Strategic Housing Development

St. Teresa's, Temple Hill, Monkstown, Blackrock, Co. Dublin

Response to ABP Opinion and DLRCC Opinion
1706A-OMP-ZZ-ZZ-SA-A-008
December 2021

This document is prepared by O'Mahony Pike Architects in response to the Opinion issued by An Bord Pleanála to the applicant Oval Target Ltd on 21st June 2021, following the tri-partite meeting of 30th April 2021.

ITEM 9

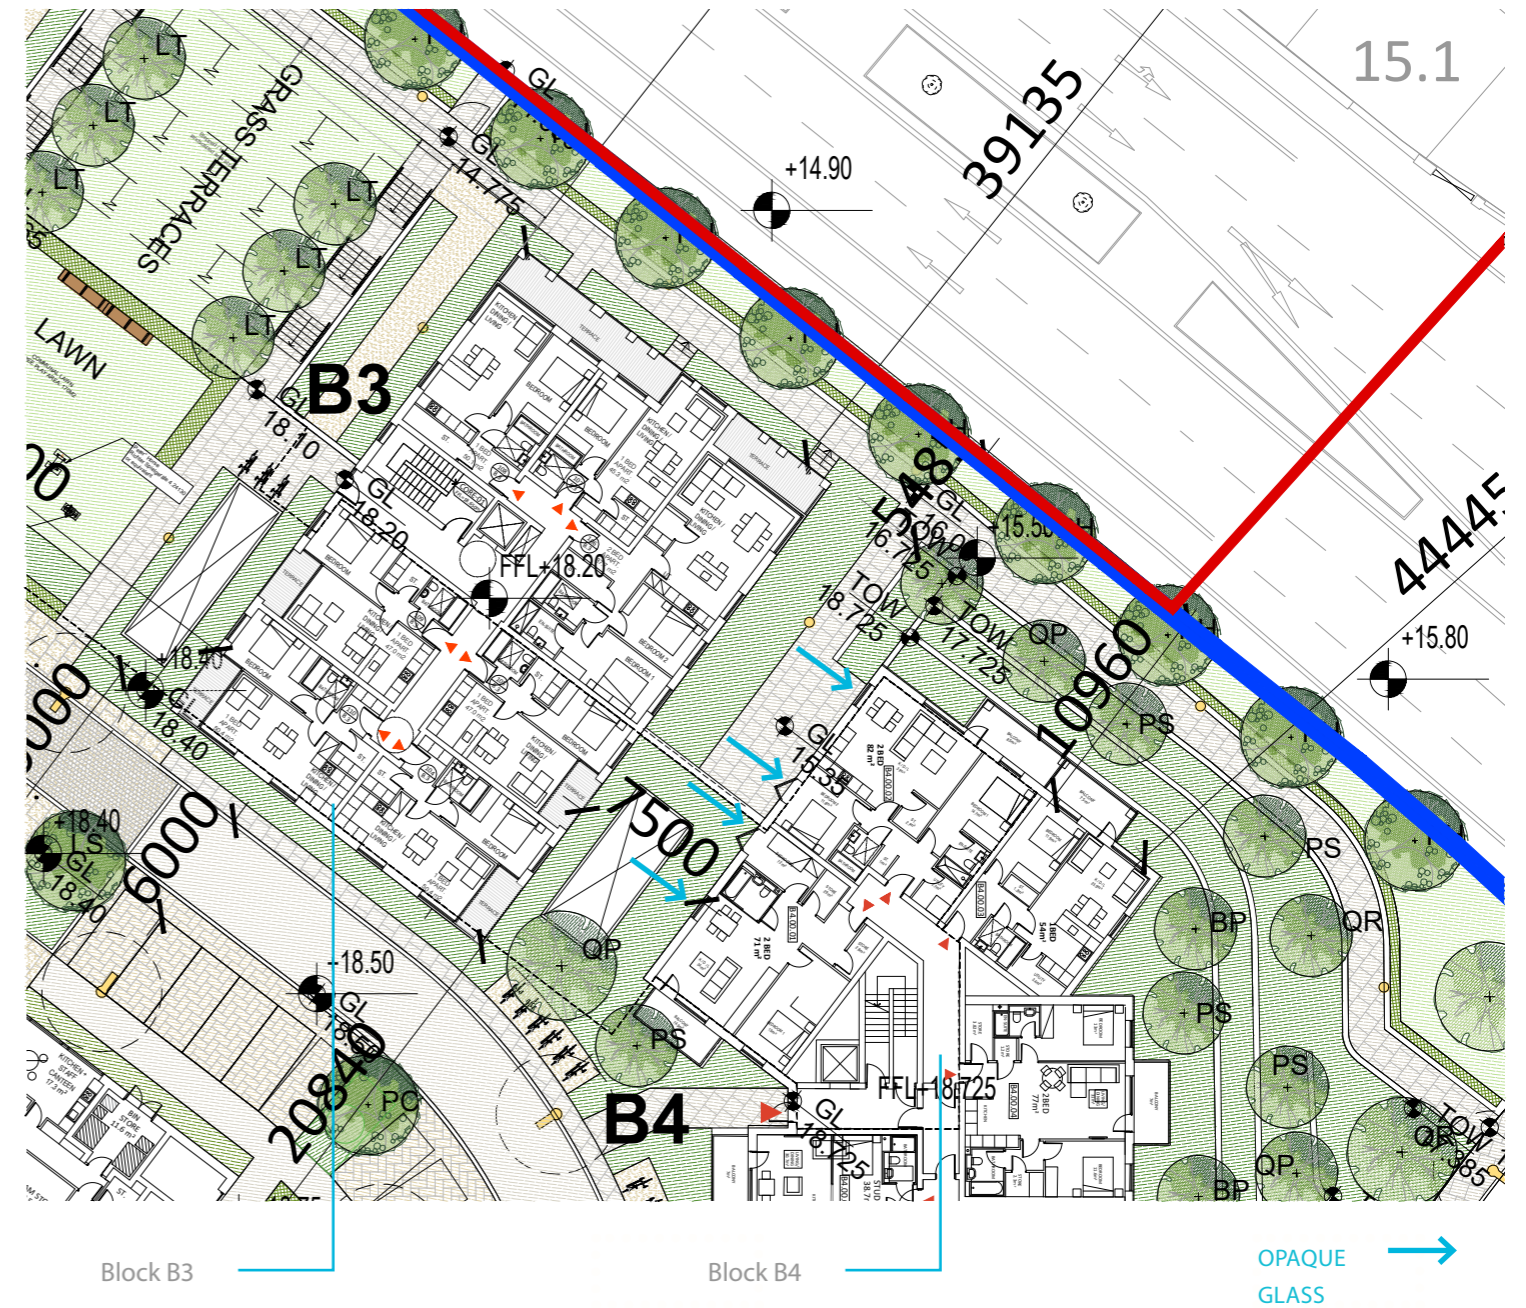
9. The Planning Authority has significant concerns regarding the separation distances between a number of blocks within the scheme. This is particularly relevant in the context of the separation distances between Block B3 and B4, Block A1 and B1 and Block E1 and E2, whereby the buildings are separated by distances of between c. 6m to 8m. This is an unacceptable arrangement, particularly in instances where balconies within the blocks directly face habitable rooms (i.e. bedrooms and living rooms) within the directly opposing apartments. This will result in a substandard level of amenity for future occupants and will not be supported by the Planning Authority. Given the heights of the buildings and the minimal separation distances provided, the Planning Authority has also concerns that the rooms within the apartments of these blocks would not achieve the recommended Average Daylight Factor (ADF), particularly on the lower levels. A more detailed analysis should therefore be provided within the Daylight, Sunlight and Overshadowing Study.

- The separation distance between proposed Blocks B3 and B4 has been increased to 7.5 m.
- Block B4 has been re-designed and windows in the gable facing towards Block B3 have been reduced in dimension.
- There are 2 no. bedroom windows per floor that will have clear glass .
- There are 2 no. secondary windows per floor to the living / dining / kitchens.
- These secondary windows are provided with opaque glass so as to protect the amenity of the occupants of apartments in Block B3 opposite.
